**WHITE LAKE TOWNSHIP
PLANNING COMMISSION**
7525 Highland Road
White Lake, MI 48383
JANUARY 7, 2021 @ 7:00 p.m.
Electronic Meeting

RE: Eagles Landing - Final Site Plan and Final Engineering Plan Review- 3rd Review

Subject: Eagle Landing Project
Final Site Plan Review #2

RE: Pontiac Lake Overlook (FKA Pontiac Lakeview Apartments)- Preliminary Site Plan Review – 3rd Review

Spillway Section "S" - "S"

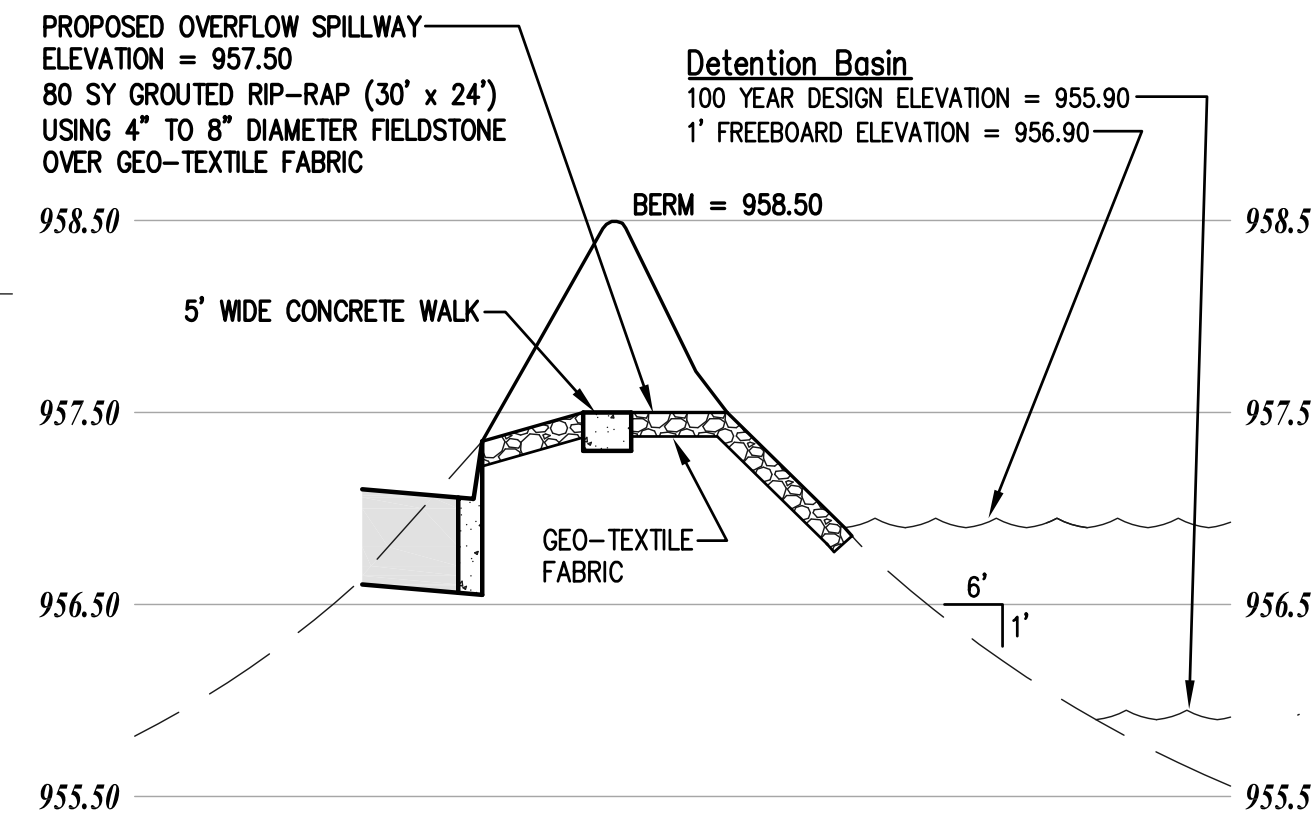
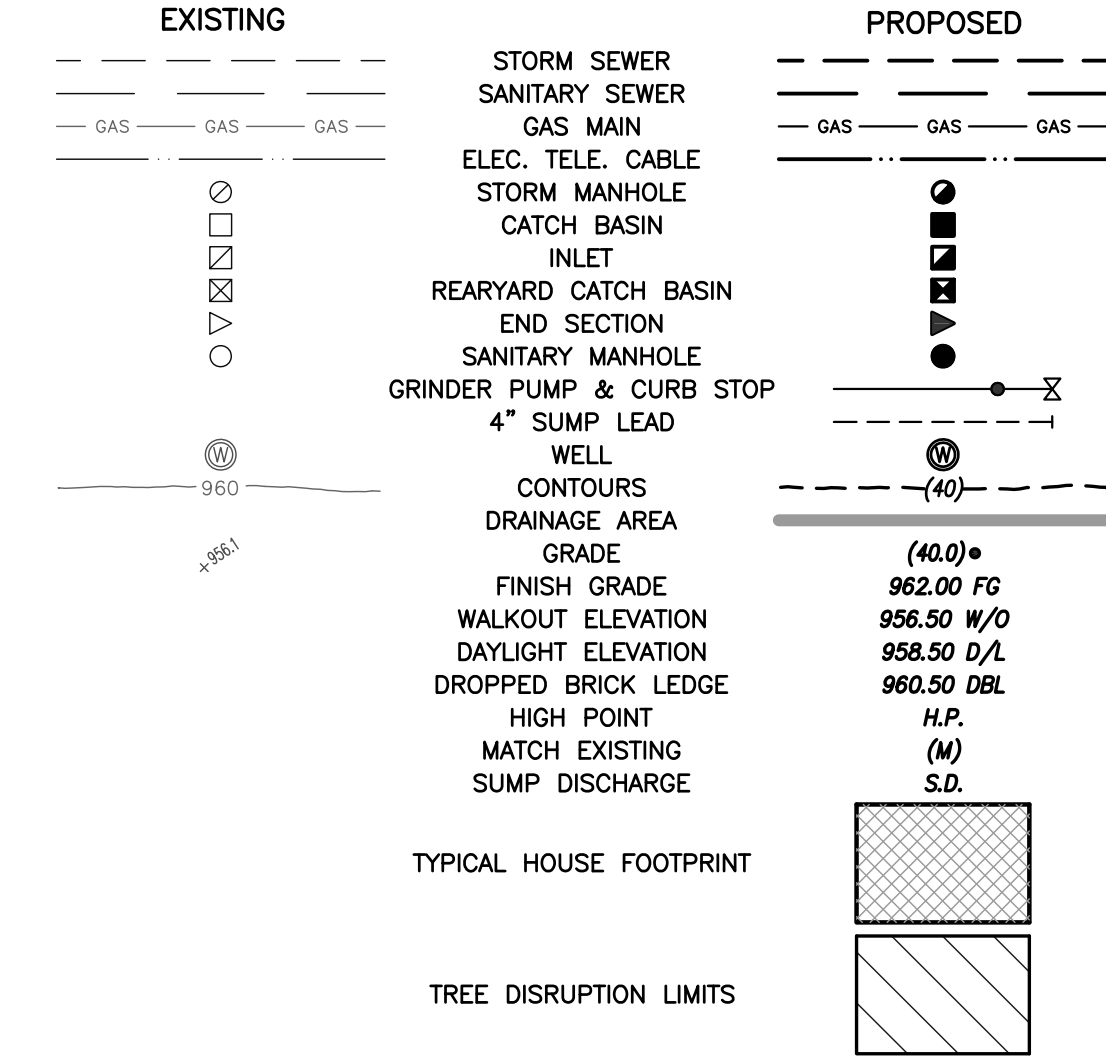
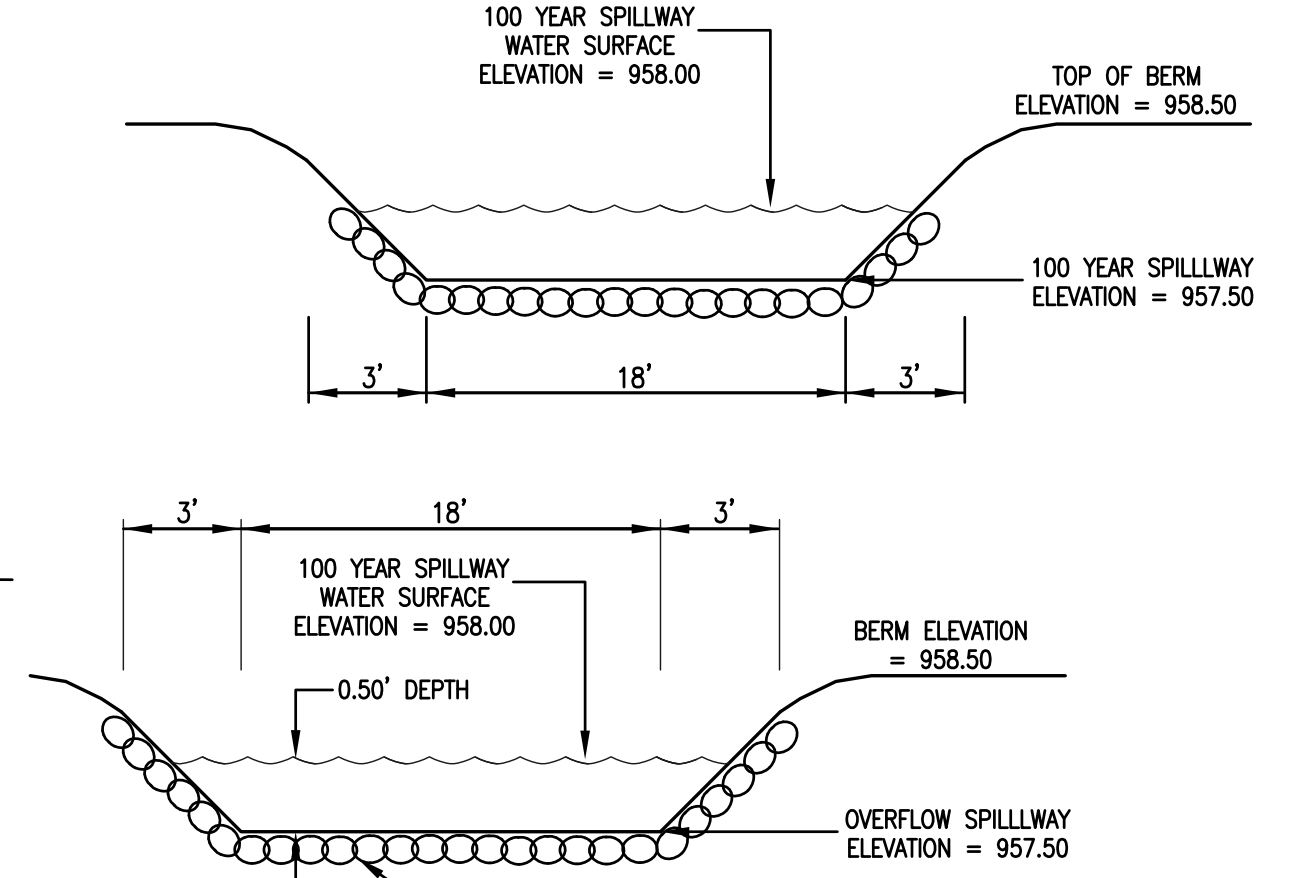
*Sheet 5 shows 957.50 @ 30'X24" for spillway in plan view with berm at 958.5. Spillway section "S"- "S" shows berm at 958.5 with spillway at 957.5. Section "S-2" needs to be indicated in plan view. This section shows spillway elevation at 957.5 and berm at 958.5 with spillway at 18'X30' dimensions. Please clarify and assure all sheets are consistent with regard to these items. **Comment addressed.***

Site/Grading Plan - East
"Eagles Landing" Site Condominium
 WHITE LAKE TOWNSHIP, OAKLAND COUNTY, MICHIGAN

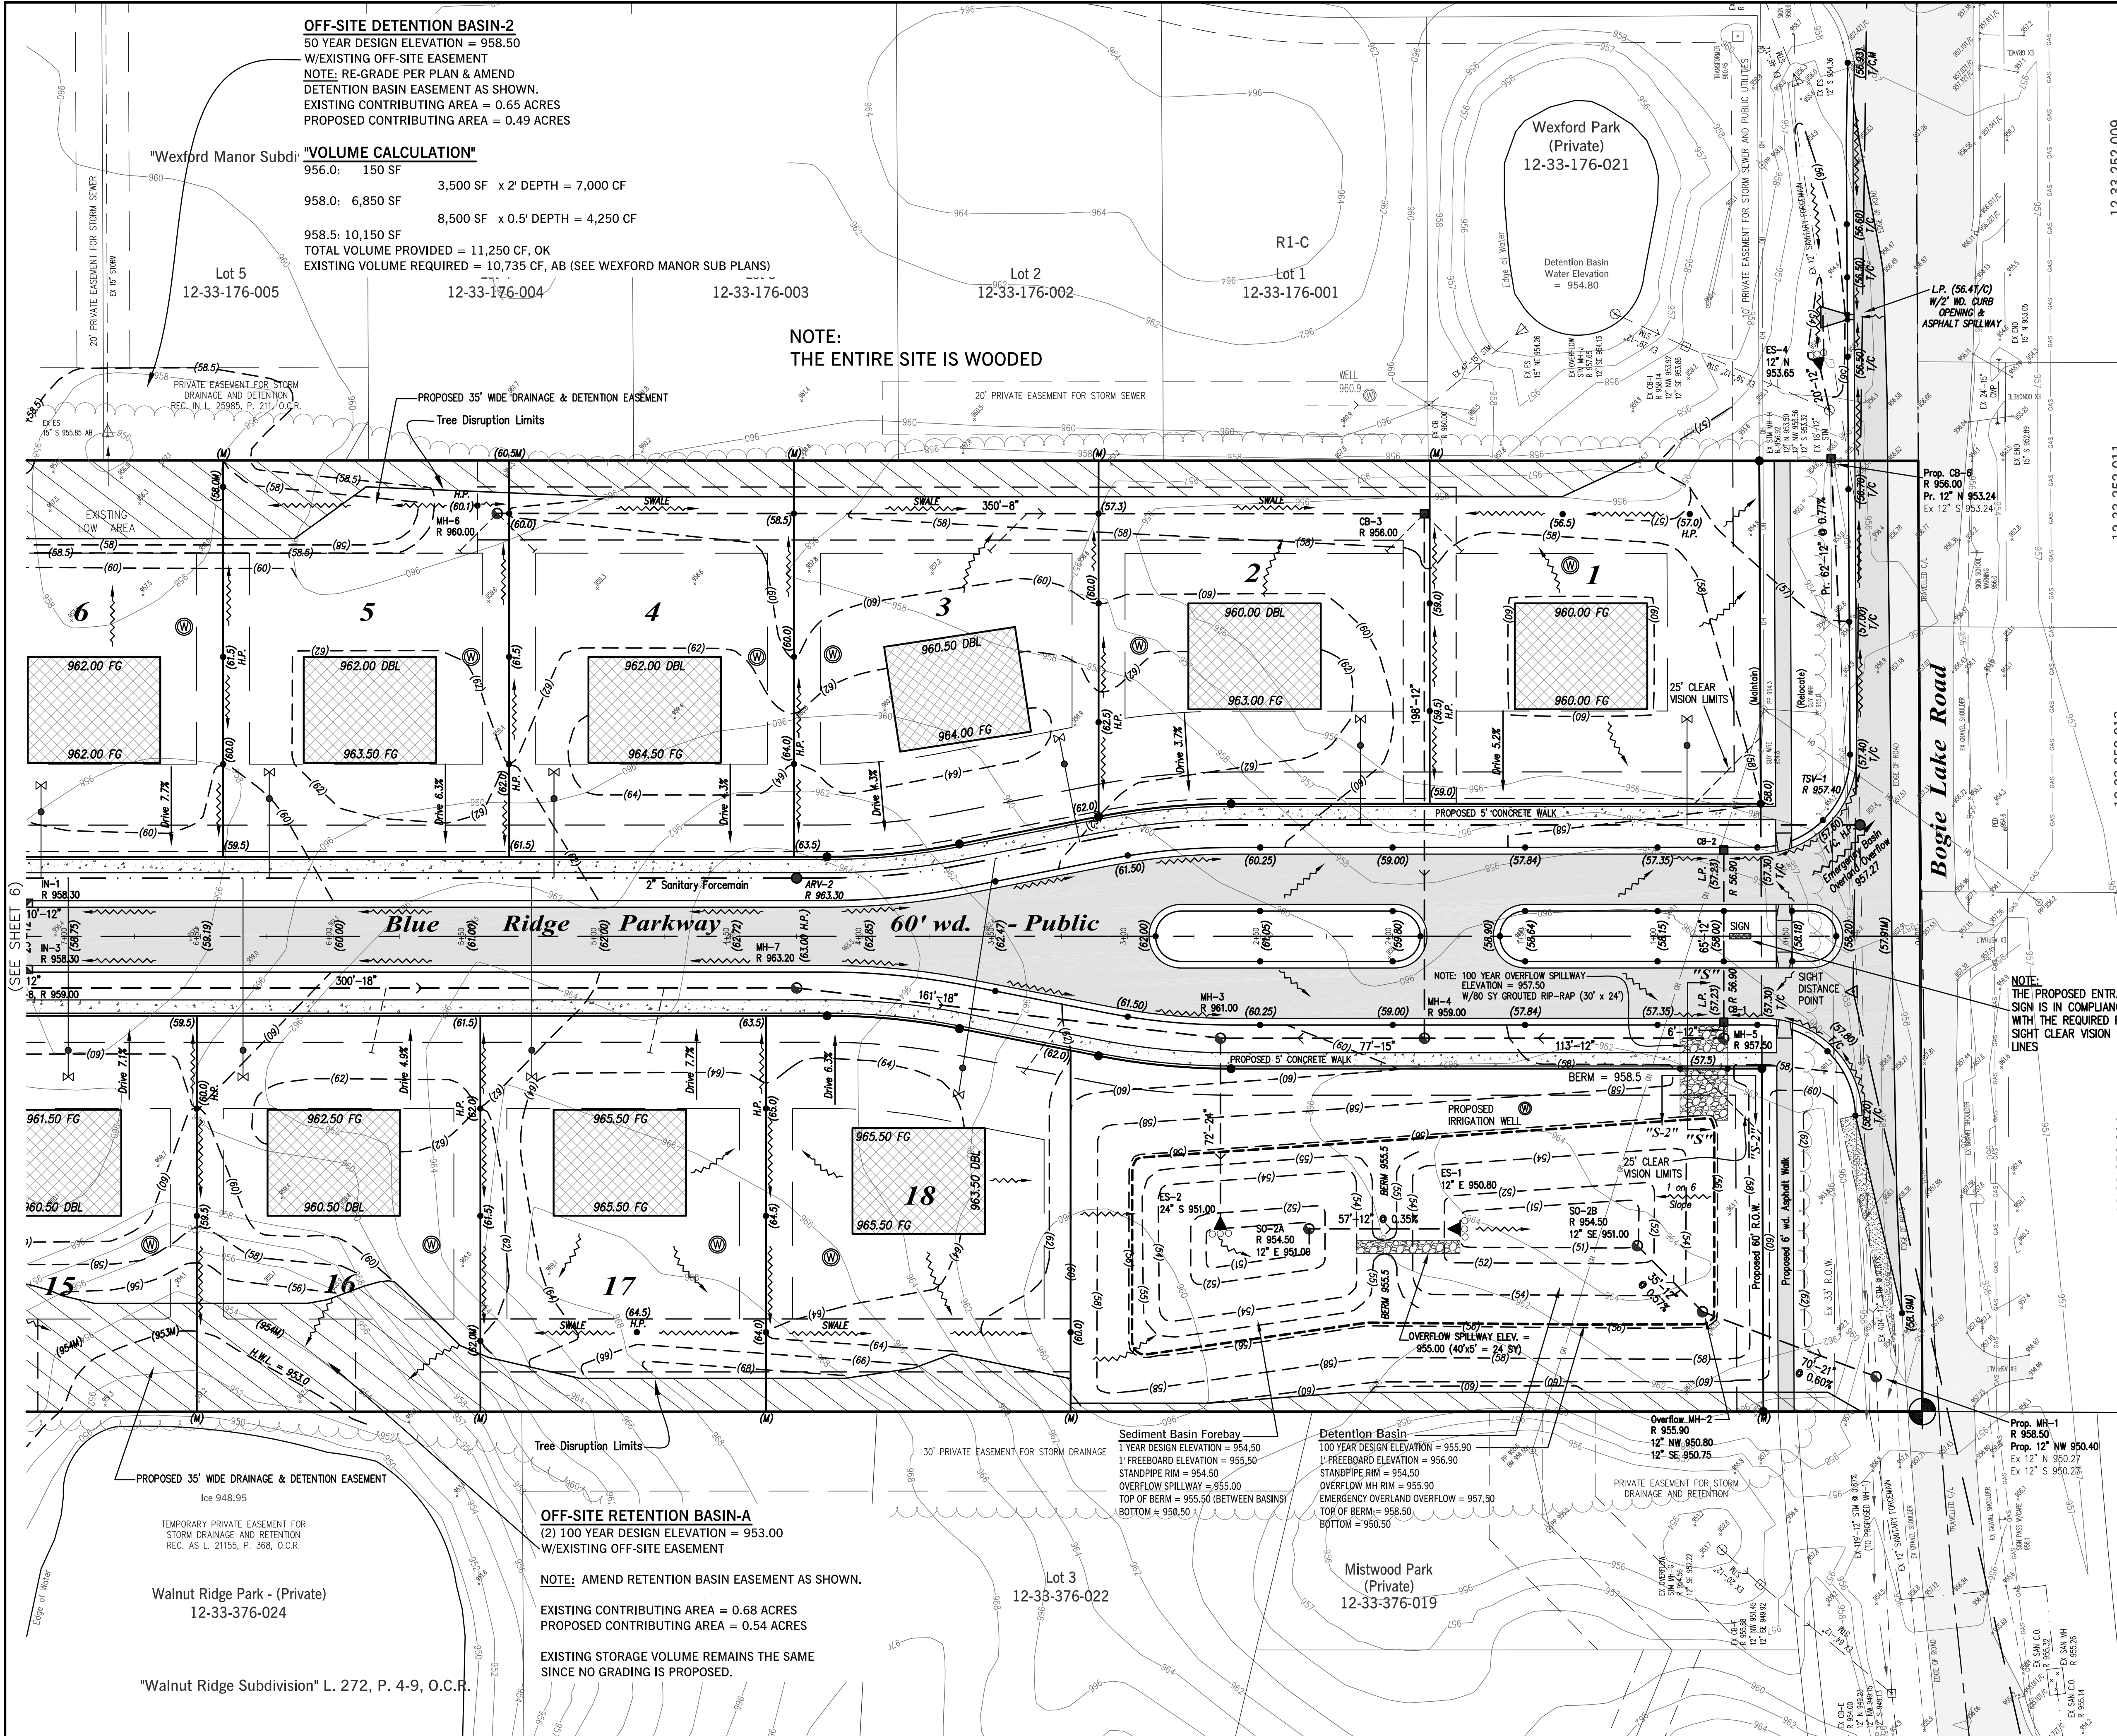
1. *Darken in the design HWL of the detention basin on all relevant sheets. Comment outstanding. We are unable to find where HWL has been emphasized. We recommend a dark dashed line be added in plan view to the basin to delineate HWL.* **Comment addressed. A dark, dashed line has been added to all relevant sheets.**
 2. *The outflow pipe located downstream of Overflow MH-1 will need to be sized to accommodate 10 year unrestricted flow.* **Comment outstanding. Design engineer has noted that they are awaiting the RCOC review since the existing pipe is only 12" diameter.**
 3. *Sheet 12- Provide detention basin spillway cross section and sizing. Note that spillway shall be armored. Comment outstanding. Sheet 12 shows spillway at 957.27 on basin profile and in detention basin calculations. Also, 957.27 on Sheet 8 with berm elevation at 958.00 on both these sheets.*
-
